May 24, 2016

Re: United Hospital Redevelopment FEIS Review
Village of Port Chester, Westchester County, New York
MC Project No. 15001515A

A. Summary of Major Concerns of the FEIS

**Additional Right Turn Lanes at
UHR Site Driveway**

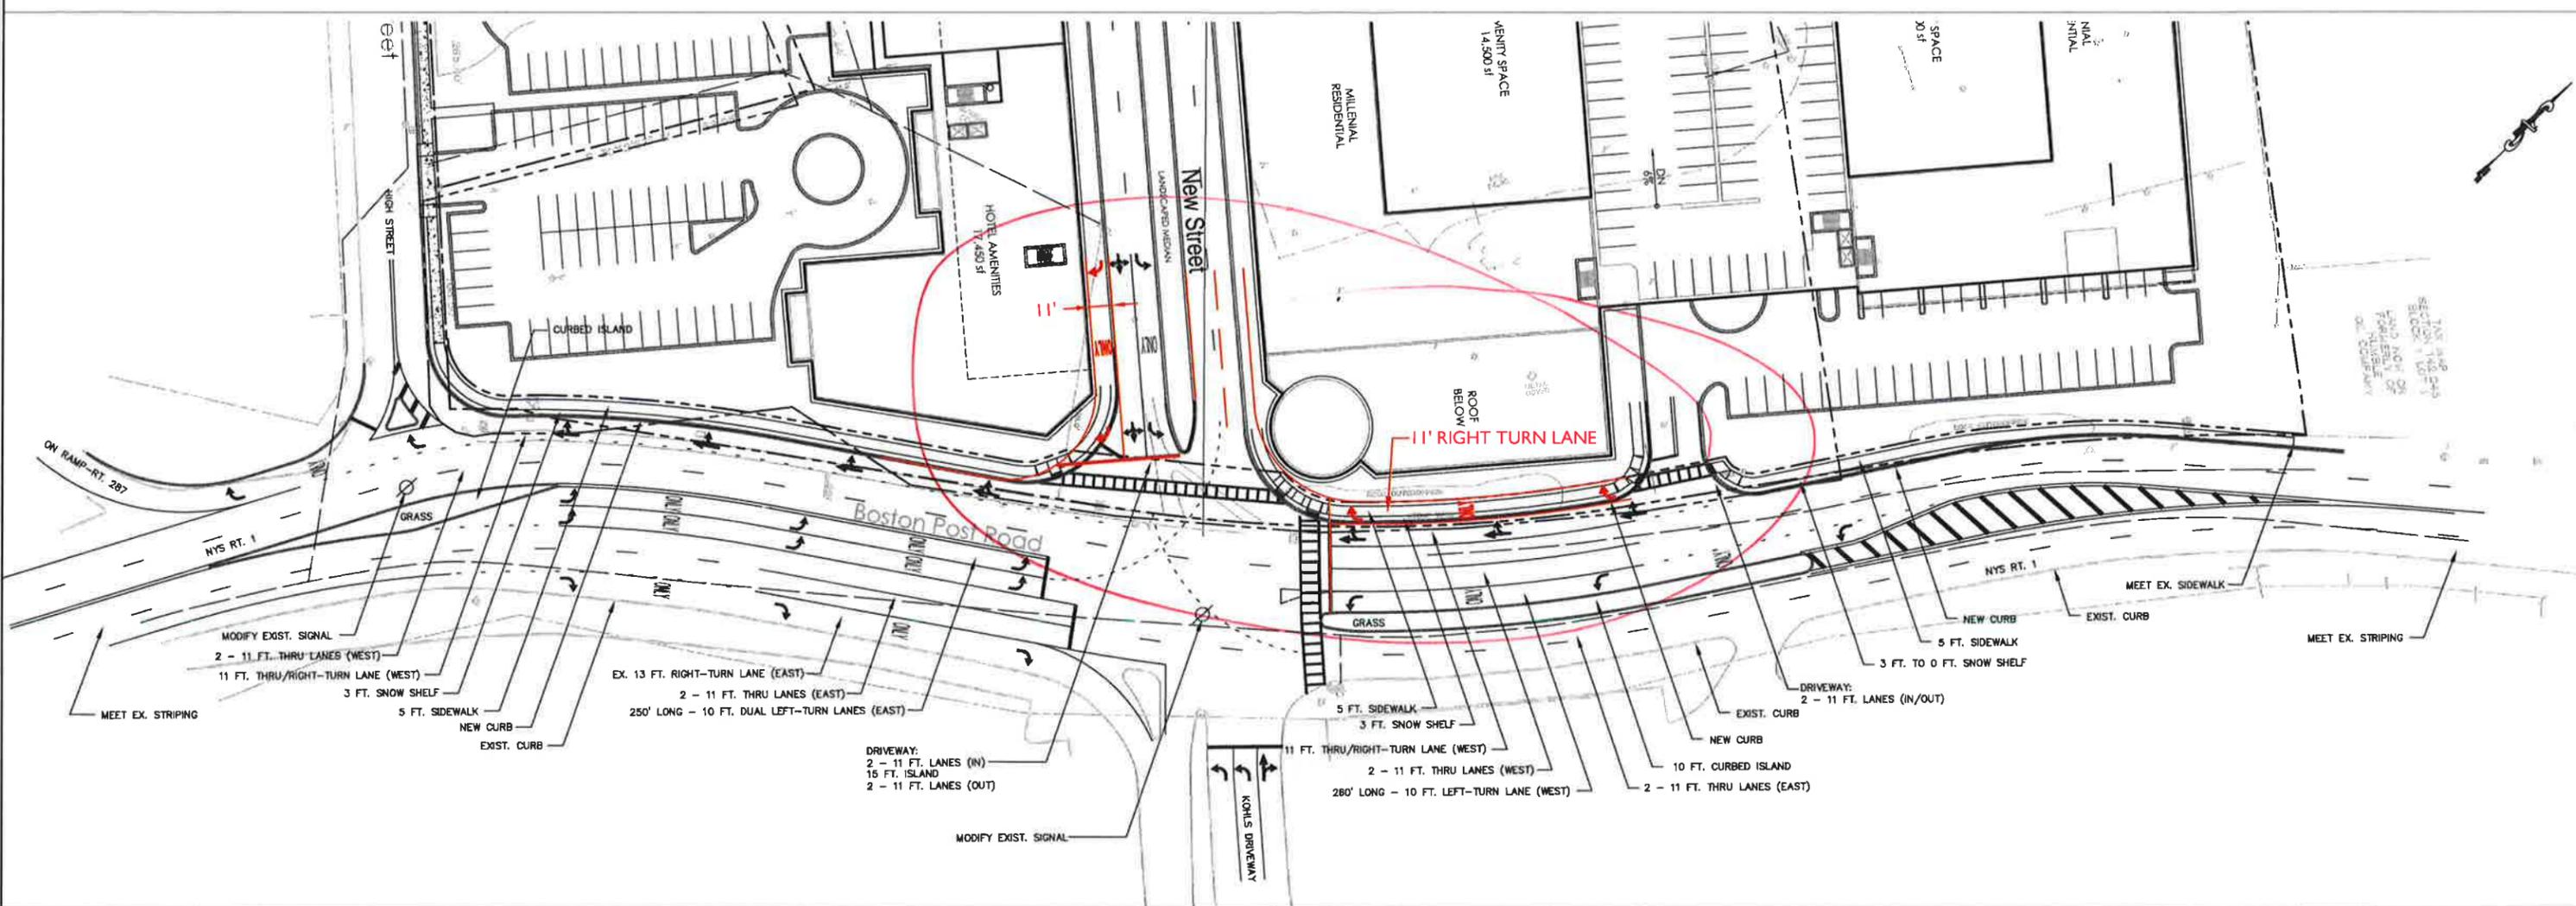
impacts of the narrow receiving lanes entering the site (two 11-ft. wide lanes), which further reduce the capacity of these turning movements (See Item 2 below). The Applicant indicates in Response E.16 that the driveway entrance and exit has been modified to accommodate a WB-50 vehicle. However, no depiction of this is provided and this is no longer an AASHTO design vehicle. Based on the NYSDOT Permit for Commercial driveways for a development of this size and considering that it will be new construction, typically a WB-62 or WB-67 sized vehicle should be accommodated at the driveway which would require a widening of the receiving lanes.

Additionally, the queues for vehicles exiting the site, which are not summarized in Tables III.E-10, 11 and 12, are also expected to exceed the storage length. This is important to consider as this roadway is proposed to become a Village of Port Chester roadway and will not only be utilized by site traffic but also by traffic currently utilizing High Street to access U.S. Route 1 northbound. If this approach cannot efficiently accommodate the site generated traffic and the diverted High Street traffic, it will result in diversions of traffic to other routes. **Other improvements including the provision of an additional right turn lane exiting the site onto U.S. Route 1 southbound as well as a separate right turn lane on U.S. Route 1 southbound entering into the site should be included as part of the proposal.**
